RE: **PETITION NO. 1573** - The Connecticut Light and Power Company d/b/a Eversource Energy Declaratory Ruling, pursuant to Connecticut General Statutes §4-176 and §16-50k, for the Brookfield Junction to Bates Rock Substation Upgrade Project consisting of the replacement and reconductoring of electric transmission line structures along approximately 6.7 miles of its existing electric transmission line right-of-way shared by its existing 115-kilovolt (kV) Nos. 1887, 1268, and 1485 Lines between Brookfield Junction in Brookfield and Shepaug Substation in Newtown, and along approximately 0.5 mile of its existing electric transmission line right-of-way shared by its existing 115-kV Nos. 1622 and 1485 Lines between Shepaug Substation and Bates Rock Substation in Southbury, Connecticut traversing the municipalities of Brookfield, Newtown and Southbury, and related electric transmission line and substation improvements. **Request for Project Change.**

Re: **PETITION NO. 1573** – The Connecticut Light and Power Company d/b/a Eversource Energy (“Eversource”) petition for a declaratory ruling for the proposed Brookfield Junction to Bates Rock Substation Upgrade Project
Proposed Project Modi

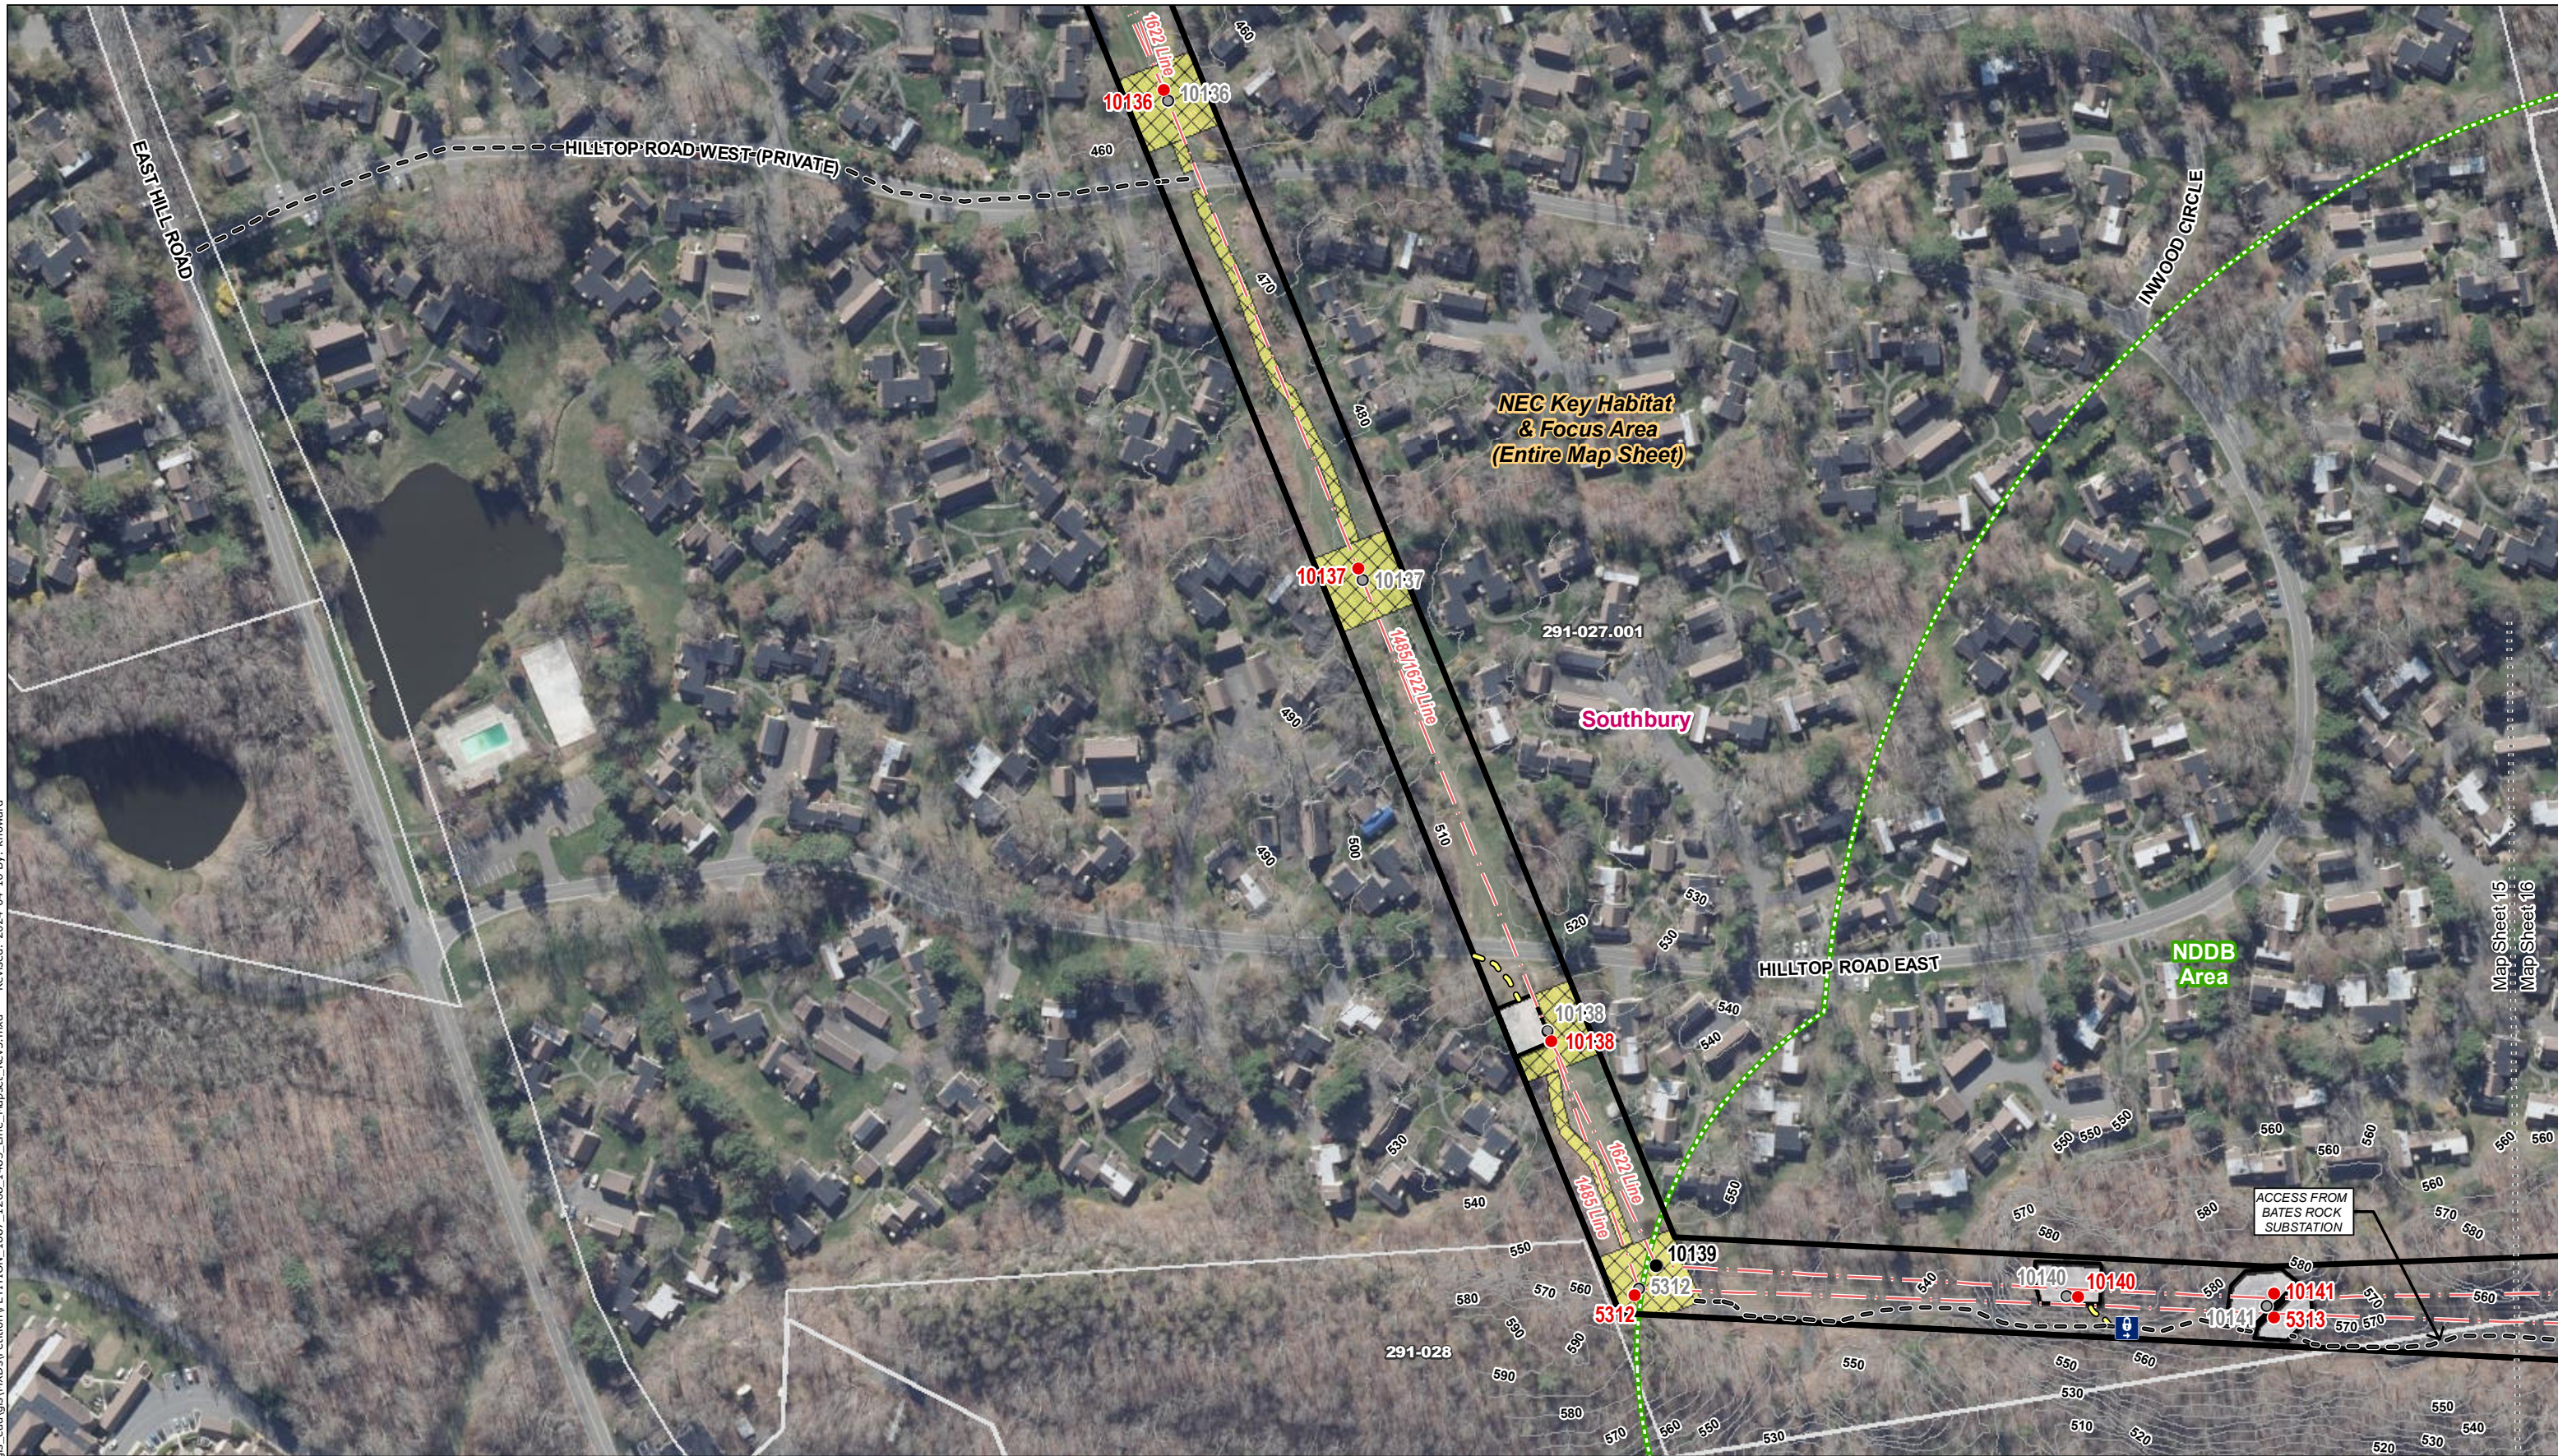
On August 4, 2023, the Connecticut Siting Council (“Council”) issued a declaratory ruling on Petition No. 1573 as referenced above. In accordance with Condition No. 1 of the ruling, Eversource is seeking Council staff approval for the following project changes, as shown on Attachment A - Map Sheet 15:

- Adding a gravel access road from Hilltop Road East to the work pad for Structure 10138
- Replacing some of the matting at the work pad for Structure 10138 with gravel

Upon closer review when starting construction, it was determined that the previously proposed matted access road from Structure 5312 to Structure 10138 does not provide enough clearance from the existing distribution line that is running parallel to the access road for large equipment to pass through the ROW.

Gravel is proposed to replace a portion of the matted work pad at Structure 10138 to provide a more stable surface on the slope on this portion of the work pad.

Pursuant to Condition No. 1 of the Council's August 4, 2023 Declaratory Ruling, the request to add a gravel access road from Hilltop Road East to Structure 10138 and replace some matting with gravel at Structure 10138 in Southbury is hereby approved.

NO.	DATE	REVISIONS
3	04/16/24	NEW ACCESS OFF OF HILLTOP ROAD EAST TO NEW GRAVEL WORK PAD AREA AT STRUCTURE 10138
2	01/18/24	ACCESS REVISED BETWEEN GUARD TRUCK PAD AND STRUCTURE 4619
1	10/12/23	PROPOSED GEORGES HILL ROAD BRIDGE REMOVED AND ADJUSTMENT TO THE CONNECTING ACCESS ALONG RAILROAD INCLUDING CROSSING
